COA (SP) 2021-006

June 16, 2021

**STAFF REPORT
SPECIAL CERTIFICATE OF APPROPRIATENESS
FOR THE PROPERTY AT
2806 GRANADA BOULEVARD
A LOCAL HISTORIC LANDMARK**

North (facing De Soto Boulevard) Elevation- Sheet A.3.1

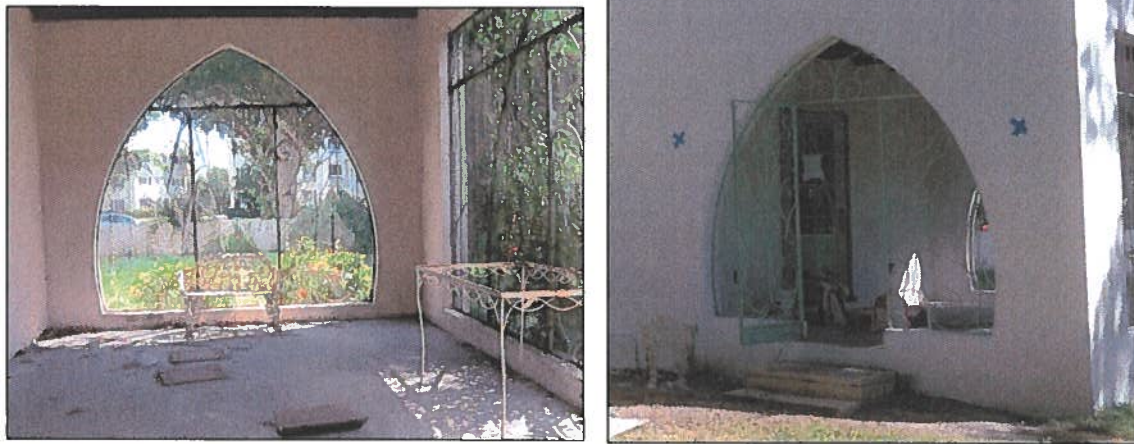
The proposal includes the demolition of the extant one-story attached two-car garage at the west end of the residence. It is to be replaced by a new one- and two-story addition consisting of an attached one-story two-car garage that is slightly expanded from the existing with a two-story portion further to the west. The two-story portion consists of a bedroom and full bathroom on each floor connected with an internal staircase. The proposed garage is taller than the existing and will tie into the roof ridge of the existing one-story family room. A single garage door framed with a stucco surround provides vehicular access to the garage. Further to the west, the two-story addition is slightly lower than the massing of the existing two-story residence. On the first floor, a single French door is flanked by single casement windows of the same proportion as those found on the existing residence. Centered above is a bay window with triple casement windows and stucco brackets below.

Please note that the windows on the existing residence do not currently have sills. The proposed north elevation includes windowsills on both the existing residence and the addition. (Other elevations show the same.) It is not clear if sills are being proposed for the existing windows or if this was a drafting error.

1. Clarify if sills are being proposed for the existing windows or if this was a drafting error.
2. Window/door muntins are to be high-profile / dimensional.

Figure 2: Rear Elevation, 2016.

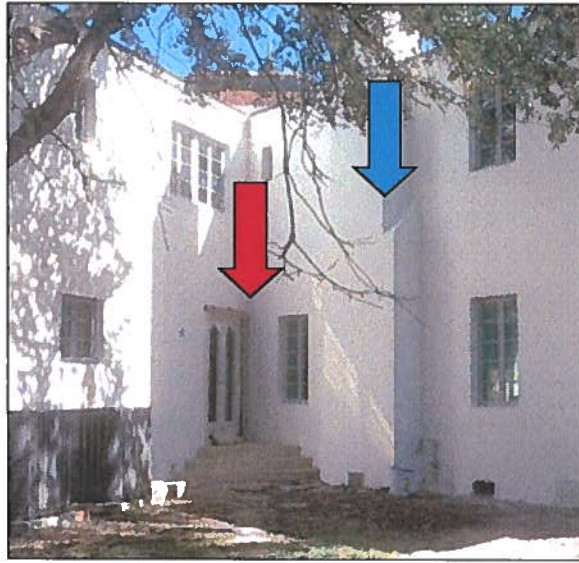
The third proposed addition consists of a small wedge placed within the “V” of the two wings of the residence. One-story in height, it provides a connection between the living room in the south wing and the dining room in the west wing. A pair of French doors in the dining room and a window in the living room will be removed to accommodate the addition (see Figure 2). In plan, the addition is reminiscent of the octagon-shaped entry tower. A pair of French doors without muntins lead out to the rear yard. This addition is topped with a pitched roof and moulded stucco cornice. A series of cascading steps (concrete with a stone finish) lead to the rear yard. Not noted on the submitted drawings is an existing sloped feature at the chimney. From the photograph in Figure 2, it appears that the stucco cornice will intersect at the chimney at this point. Staff would like clarification about how this feature will be addressed.

**Red arrow indicates location of addition and window/door to be removed;
Blue arrow indicates chimney detail to remain.**

7. Provide clarification about how the chimney feature will be addressed or affected by the first-floor addition.
8. The French doors at the new rear addition are to receive muntins to match those shown at the two-story addition.
